Recall Information Bulletin

No: C1006110 **Issued:** 1/7/2013

Re: 4M50 Fuel Pipes

Safety Recall C1006110 – 4M50 Fuel Pipes

figure2-1.Remove the inlet system parts

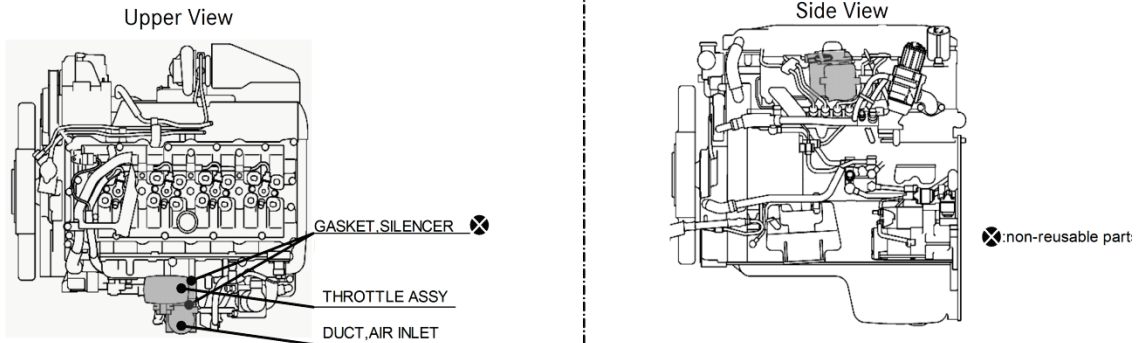
The throttle assembly gaskets (Kit # EXLT111GAE includes both gaskets) must be replaced as they are non-reusable (Fig. 2).

Figure 3 Repair Process Flow chart

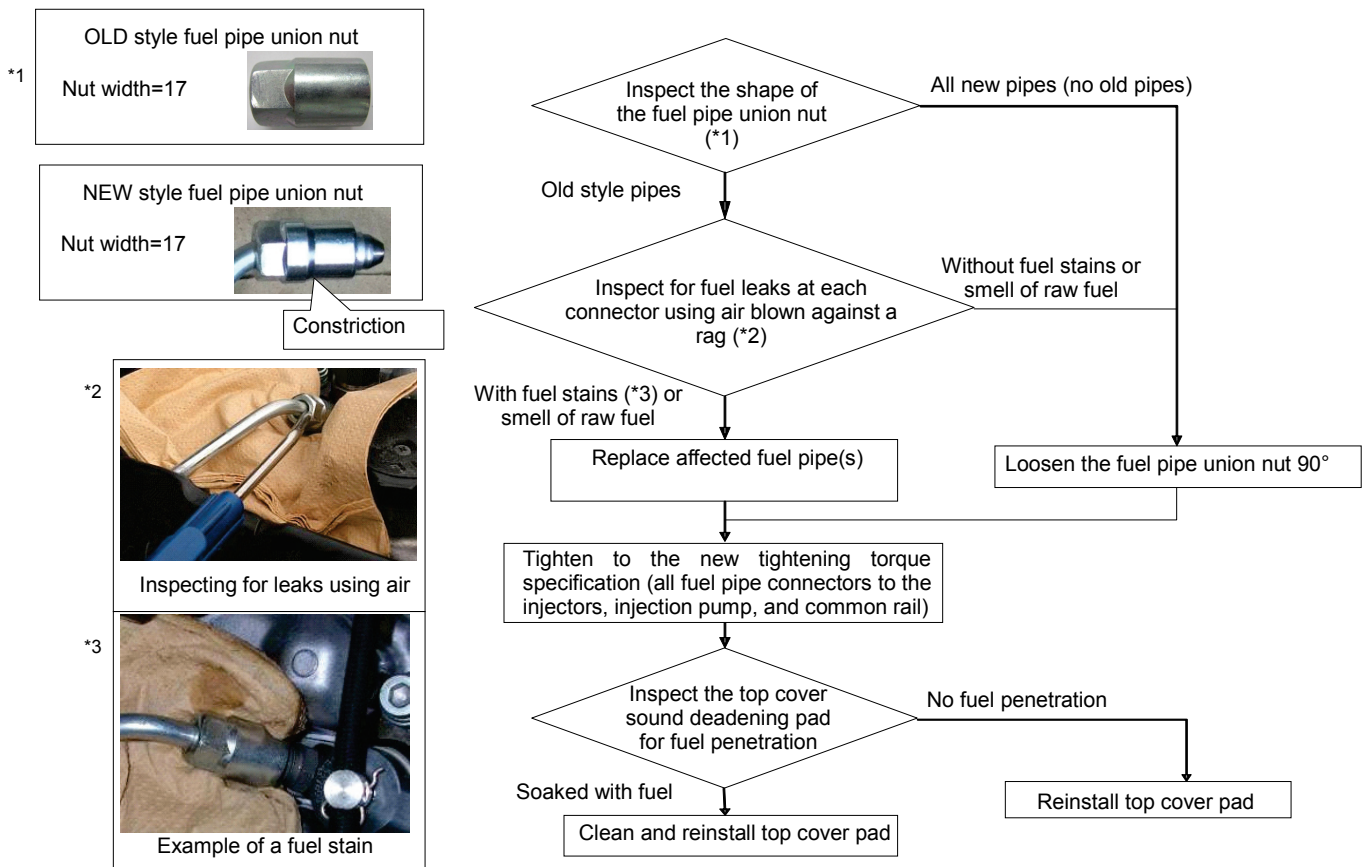
If a fuel leak is confirmed, replace only the leaking fuel pipe(s).

If liquid stains the rag when air is blown at the connection, clean the connection and surrounding area, start the truck and allow it to idle for 1-2 minutes, then check for leaks again to ensure that the initial liquid stain was actually caused by a fuel leak, and not residual engine oil or other fluids.

Figure 4. Locations of the fuel pipe connectors

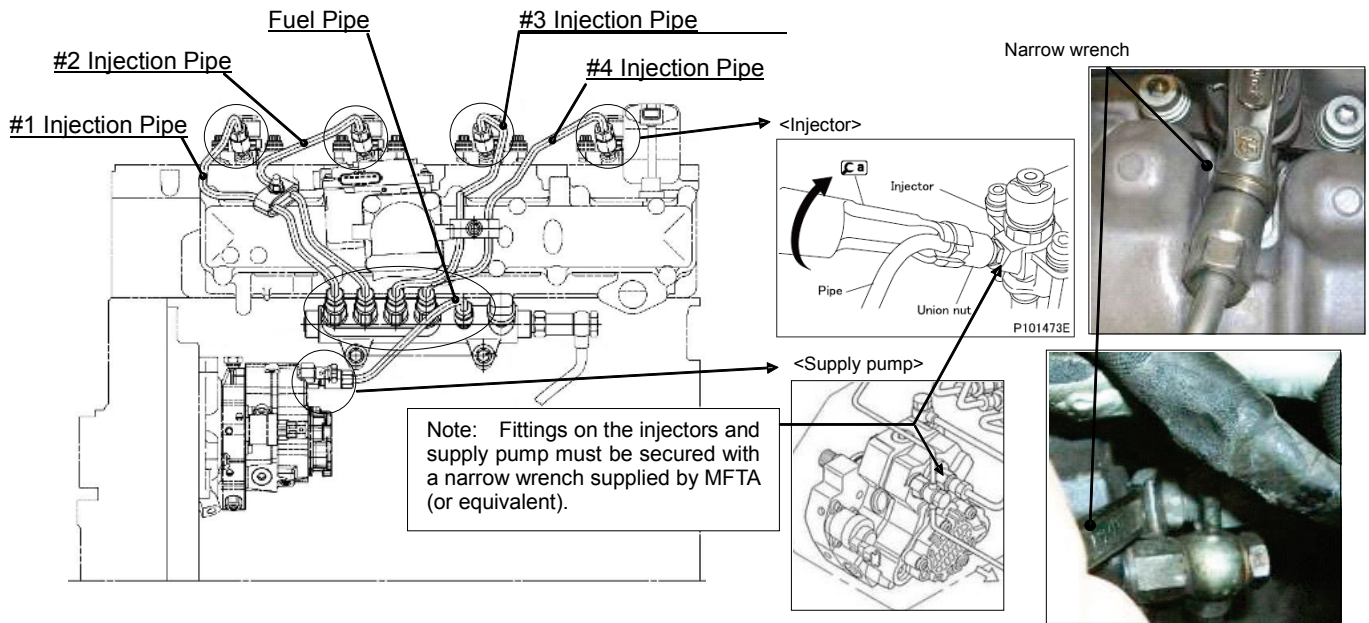
All fuel pipe connectors for the indicated 10 locations must be tightened to a torque of 28 - 31 ft.lbs. [38 - 43 Nm]. (Fig. 4)

Note: When removing and installing fuel pipes, a narrow wrench supplied by MFTA (or equivalent) must be used to hold the injector and fuel pump fittings in place to prevent them from turning while the fuel pipe connectors are tightened.

(4) If **NO** fuel leaks are found, loosen all fuel pipe connectors 90°, then tighten the connectors to 28 - 31 ft.lbs.

If a fuel leak is confirmed, replace the affected fuel pipe(s) and tighten the connector(s) to 28 - 31 ft.lbs.

[38 - 43 Nm]. Then, loosen the remaining connectors 90° (¼ turn only!), and tighten the connectors to 28 - 31 ft.lbs.
